STATE OF TENNESSEE DEPARTMENT OF ENVIRONMENT AND CONSERVATION DIVISION OF WATER RESOURCES

Re: **NOTICE OF VIOLATION**

Complaint # 128413 Cattle Trails Estates

TNCGP Tracking Number(s): TNR244178

Attachment 2: sedimentation of unnamed tributary to Long Branch at outfall located below failed sediment basin

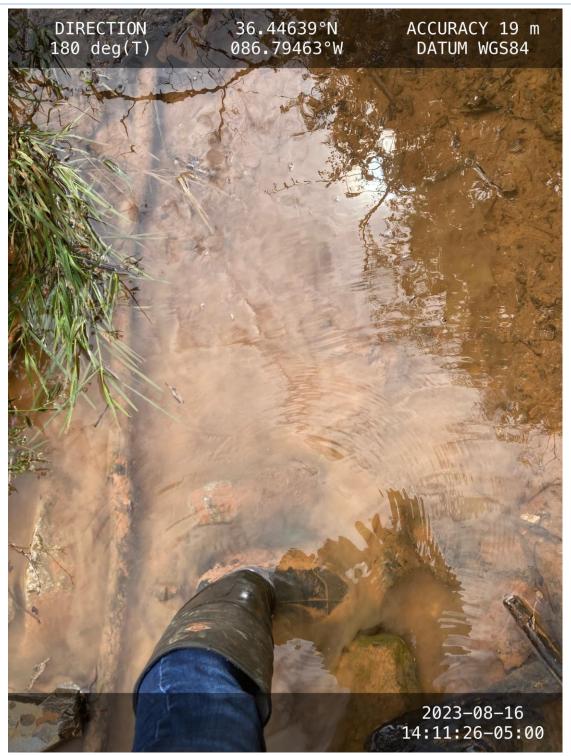
Attachment 3: sediment deposition approximately 4 inches at outfall

Attachment 4: sedimentation of unnamed tributary to Long Branch

Attachment 5: view of sedimentation of unnamed tributary to Long Branch

- 1. Immediately install and repair effective EPSC measures to ensure adequate treatment of the site's stormwater discharge. Provide photos showing improved EPSCs.
- 2. Within 7 days of receipt of this letter, remove any sediment deposited in the stream. This work must be done without the use of heavy equipment where surface water is present (e.g. using only a shovel and bucket or tools that can be carried by hand).
- 3. Within 20 days, submit a Corrective Action Plan (CAP). The CAP should outline the improvements to EPCSs (structural and non-structural) to prevent sediment from leaving the site, timelines for addressing the issues, and explain how you intend to prevent future impacts.
